ASSESSMENT REPORT

Section 96(1A) Modification Port Kembla Bulk Liquids Terminal (SSD 7264 MOD 1)

Figure 2: Development Sites 1, 2, 3, Berth 104 and Surrounding Land Uses (TQ Holdings, 2016)

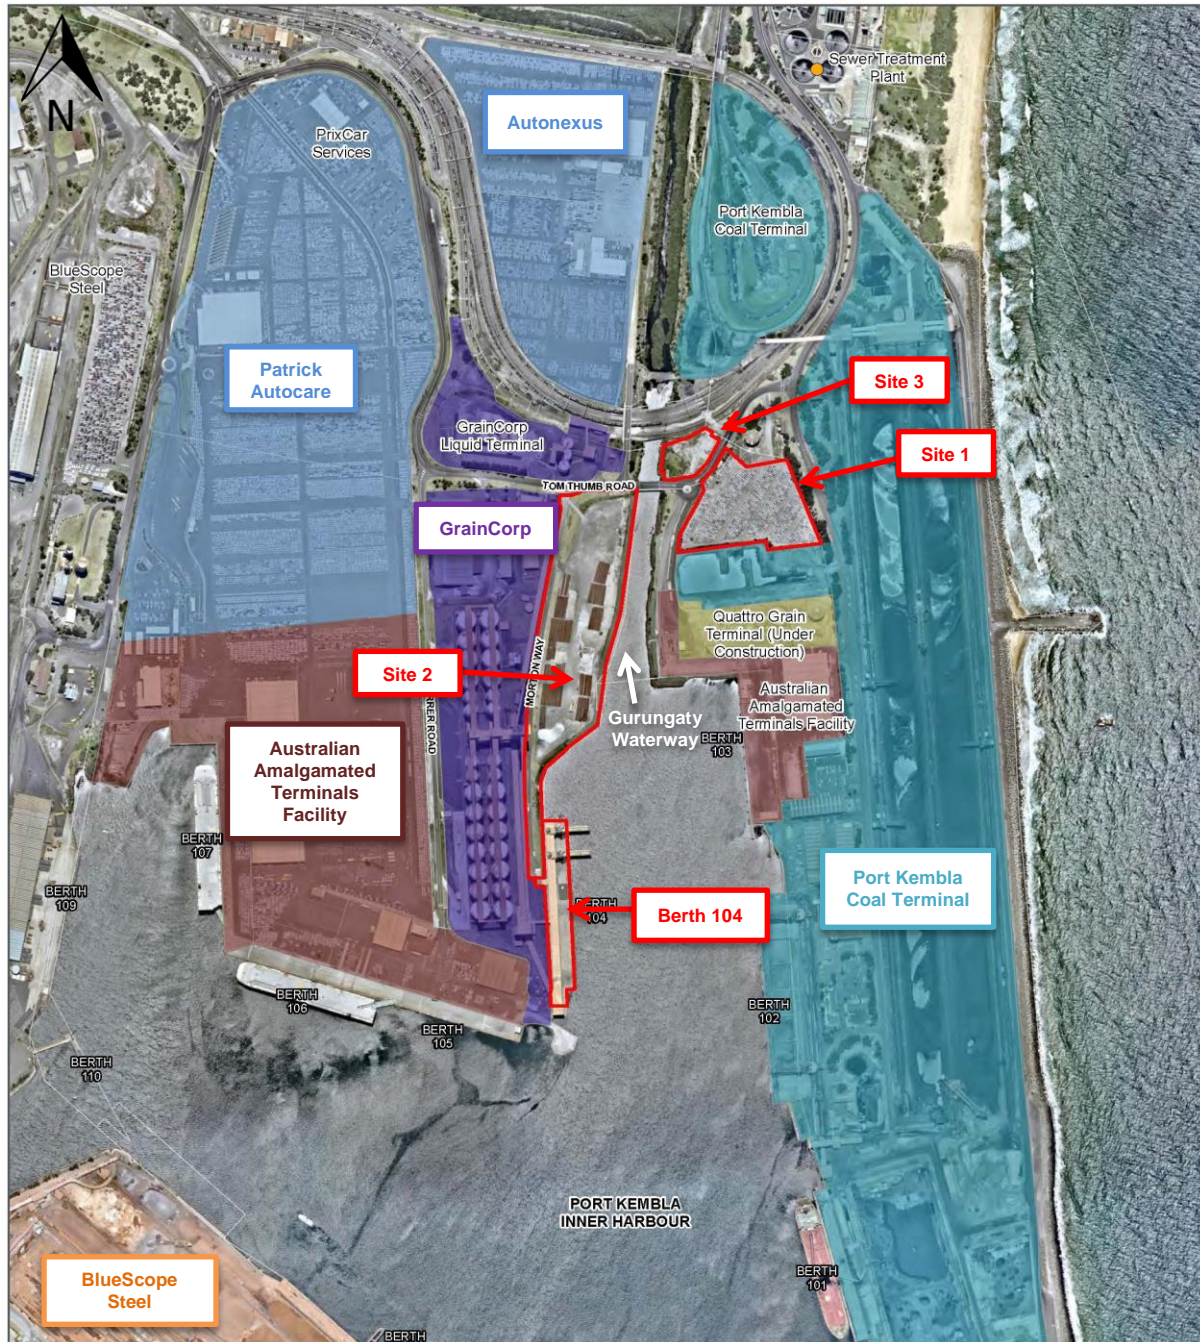
A submission was received from GrainCorp who raised concerns regarding the potential for the proposed development to encroach upon GrainCorp's future development options along the site boundary, adjacent to the eastern fence-line (west of Site 2, see **Figure 2**). This is due to the proximity of the development's flammable tanks and bunds to the GrainCorp facility. The Applicant provided a response to their concerns, noting this aspect of the design has been discussed with GrainCorp previously. The Applicant also confirmed the development would be designed in accordance with the relevant Australian Standards to ensure it would not encroach upon GrainCorp's lease boundary. The Department is satisfied with the Applicant's commitments, and has recommended it ensures the storage and handling of Dangerous Goods is undertaken in accordance with the requirements of all relevant Australian Standards, Codes and Regulations.

Figure 4: Overview of proposed tank and equipment relocations (TQ Holdings, 2016).

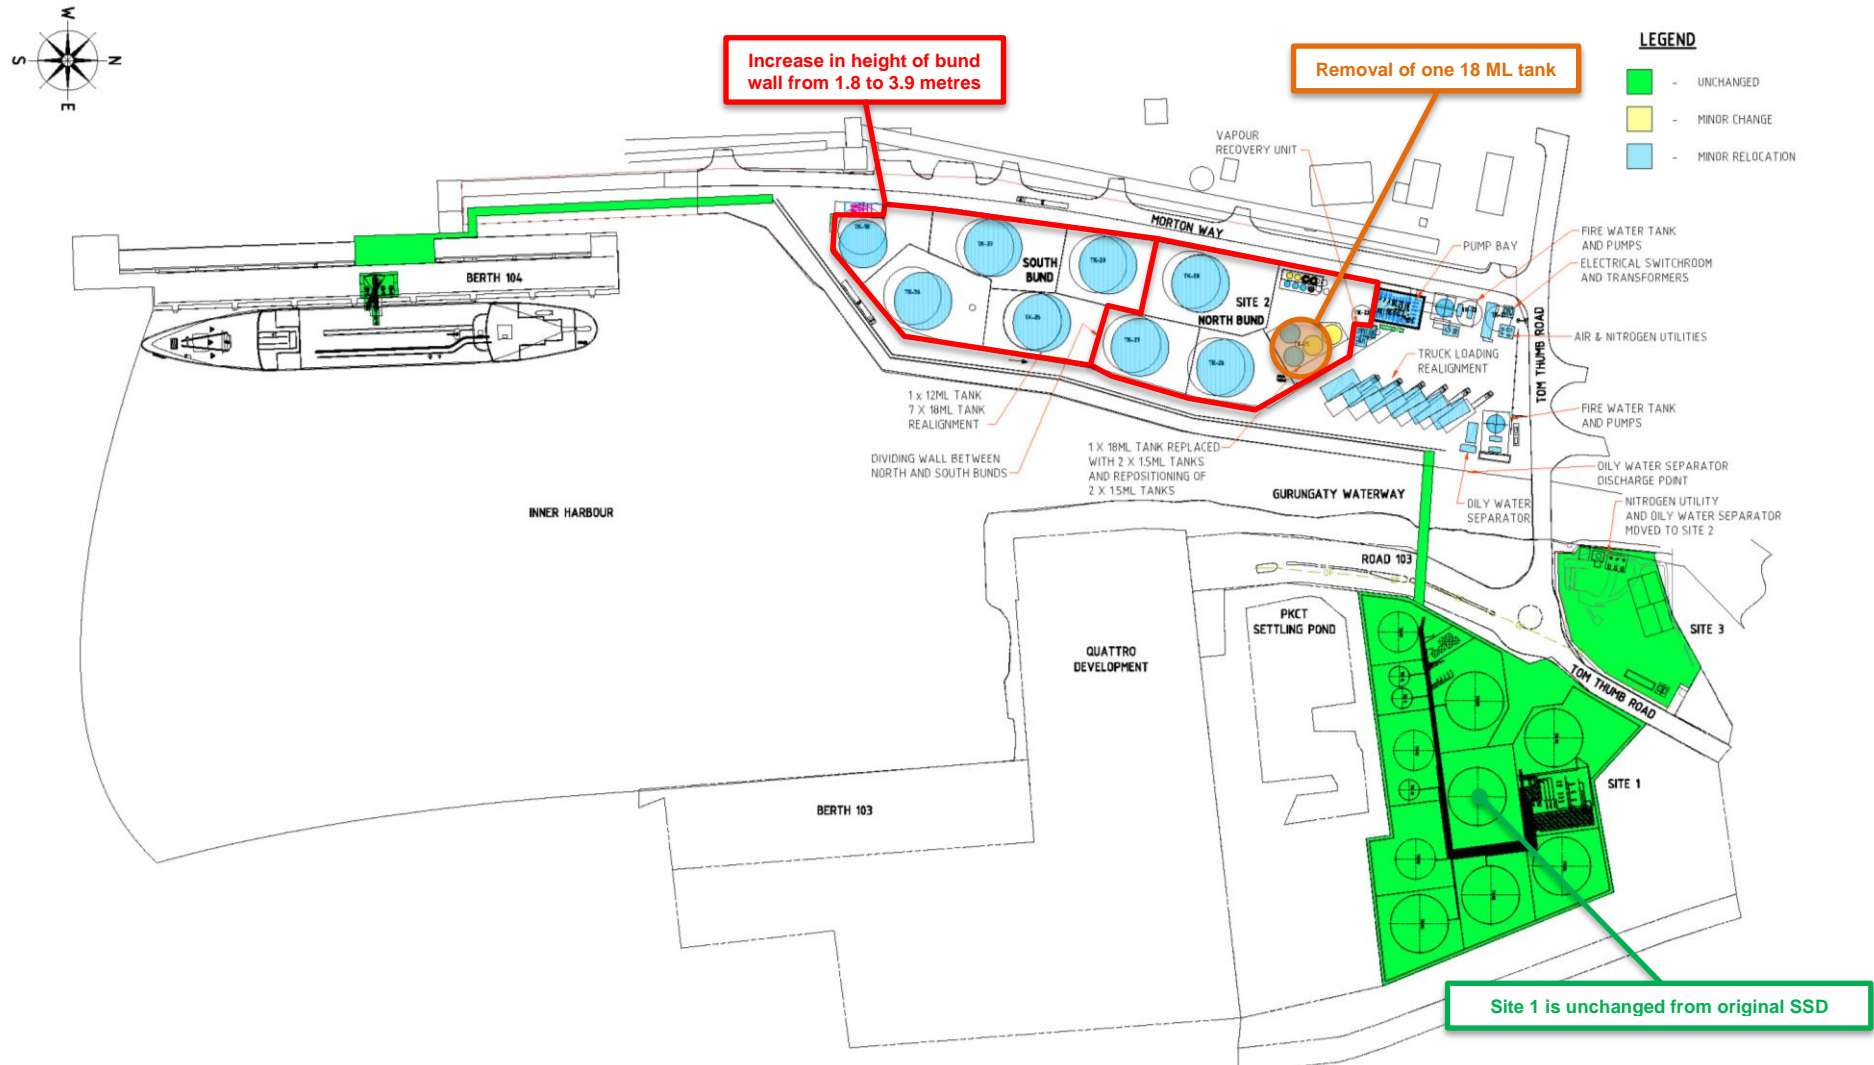
<i>Fire water system</i>	<p>The proposed modification also seeks to separate the fire water tanks and pumps located on Site 2, as a result of further consultation undertaken between the Applicant and Fire and Rescue NSW (see Figure 4). One set of equipment would be located in the north eastern corner of Site 2, whilst the other would be in the north western corner of the site.</p>
<i>Relocation of Site 2 Equipment</i>	<p>The proposed modification would involve the relocation of several pieces of equipment on Site 2 (see Figure 4), including the:</p> <ul style="list-style-type: none"> • vapour recovery unit; • additive and slops tanks; and • pump bay.
<i>Relocation of Site 3 Equipment to Site 2</i>	<p>The proposed modification would involve the relocation of several pieces of equipment from Site 3 to Site 2 (see Figure 4), including the:</p> <ul style="list-style-type: none"> • oil separator; • nitrogen vacuum insulated evaporator; and • air compressors.

Figure 5: MOD 1 Individual Fatality 50E-06 per Year Risk Contour (Sherpa Consulting, 2016).

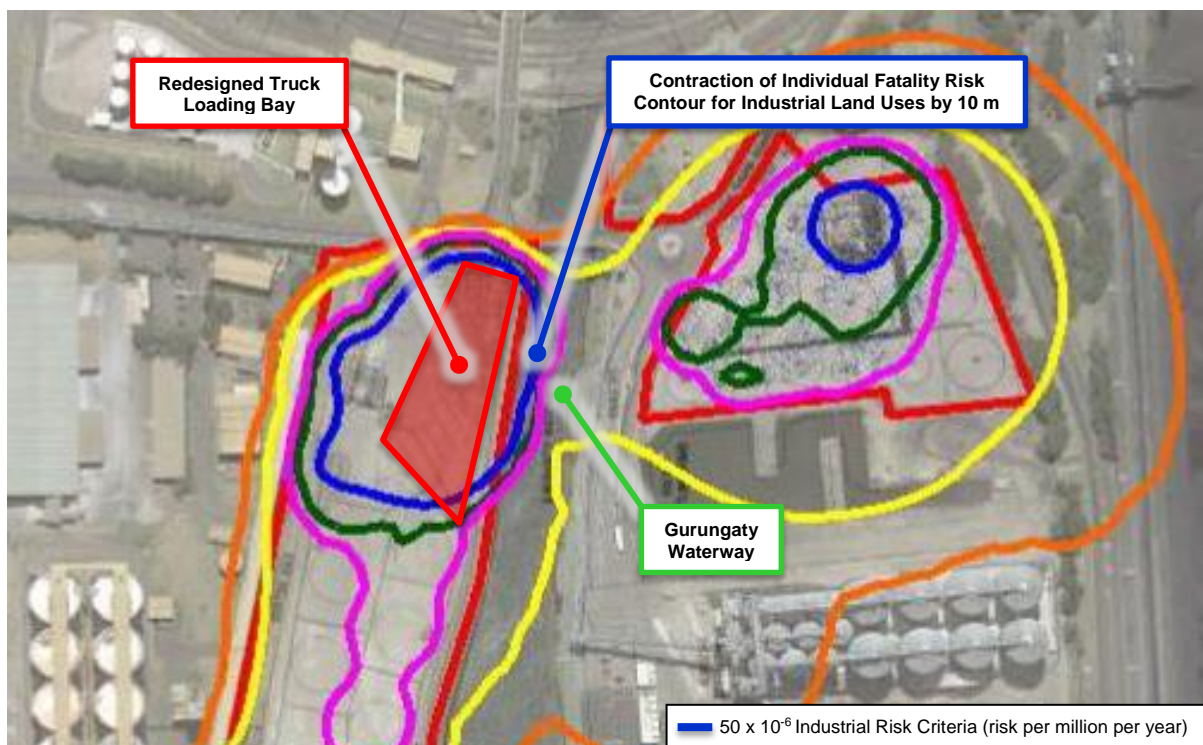
However, the PHA indicates the individual fatality risk contour for industrial land uses (50 per million per year) would extend off-site by around 10 m into the Gurungaty Waterway (see **Figure 5**, blue contour). The Department notes this exceedance was previously addressed in the original SSD application, in which the industrial risk contour extended off-site by around 20 m into the Gurungaty Waterway. Given it was unlikely personnel or the public would be present within the Gurungaty Waterway at any time, the Department's original assessment concluded the 20 m exceedance would not pose a significant risk to nearby industrial land uses. Accordingly, the Department considers the 10 m exceedance would result in a slight improvement upon what was assessed as part of the original SSD application. This improvement in risk can be attributed to the reduction in total storage quantity and change in design layout of the development.
